AQUIND INTERCONNECTOR

Statement of Common Ground Between
AQUIND Limited and the Marine Management
Organisation

Document Ref: 7.5.16

DOCUMENT: STATEMENT OF COMMON GROUND

Figure 1. Benthic baseline PSA results based on Folk Classification. No grabs returned from sampling stations 8 and 22. (taken from Figure 9, Benthic Ecology Survey Report)

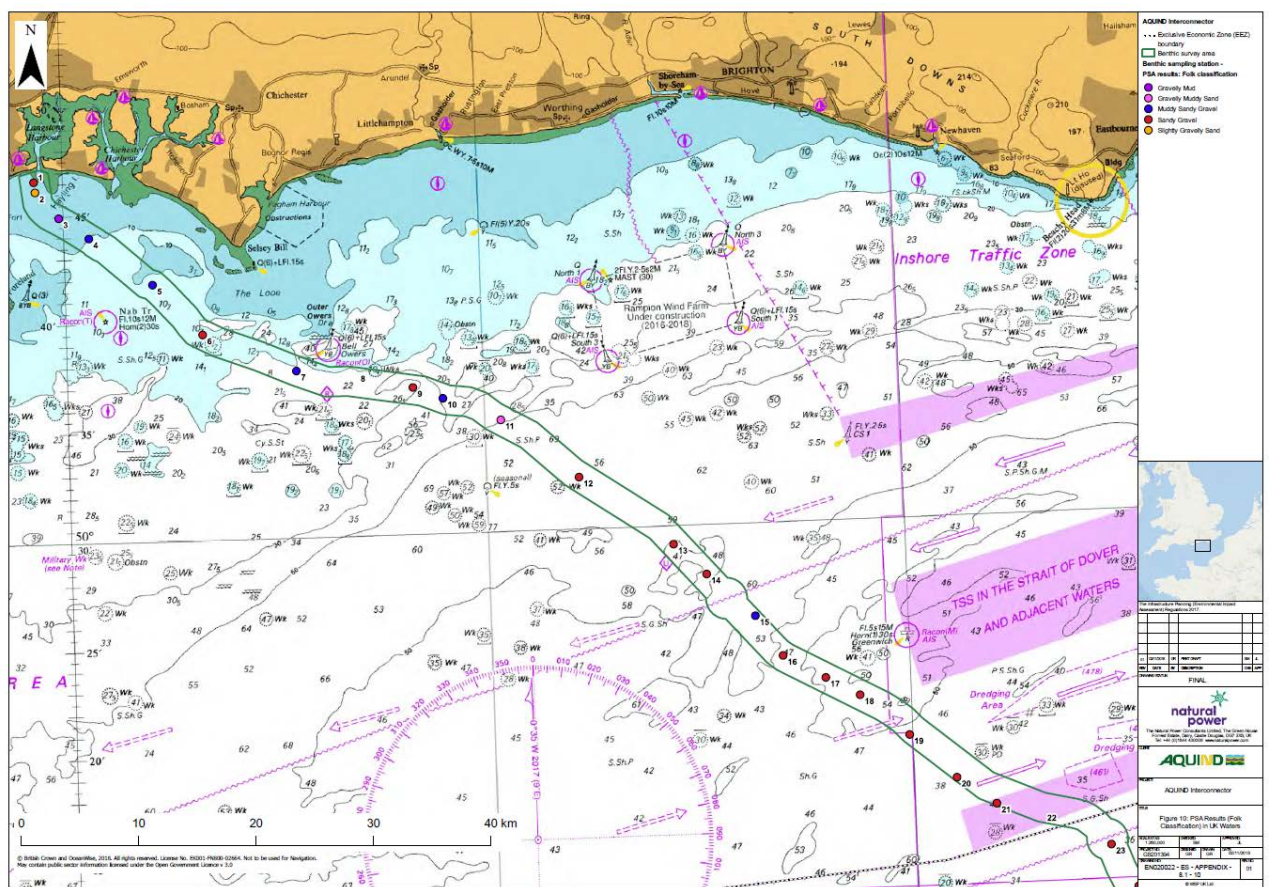
- 8.12. The applicant has noted the following in 7.4.3 (Chapter 7): “Coarse sediment has a limited affinity for sorption of chemical contaminants and therefore sediment contamination would not be expected to pose a significant risk in the offshore areas of the route given the PSD results.”

- 8.13. The point above is an acceptable premise, so long as PSD data are provided to verify that the proposed work area is appropriate. Appendix 6.3 details the grain size statistics and Appendix 8.1 details the findings of the Benthic Ecology Survey Report. Figure 1 (below) displays a map detailing the PSD of the sampling grab locations. From the location of grab station 12 up to station 23, sediment is classified as either sandy gravel or, in one instance, muddy sandy gravel. The MMO consider this acceptable evidence that sediment in the offshore segment of the cable corridor (approximately 50 km from the shore) is sufficiently coarse such that additional sample contaminant analysis is not, at this time, required.

- 8.14. In the nearshore section of the cable corridor, grab samples show a mixture of sandy gravel, gravelly mud and slightly gravelly sand, but are predominantly muddy sandy gravel. This indicates that material from the nearshore section is less consistently coarse than the offshore section. Table 1 (below) details the coordinates of the sampling locations of the sediment contaminant analysis; in order to compare how they represent the nearer shore section of the cable corridor.
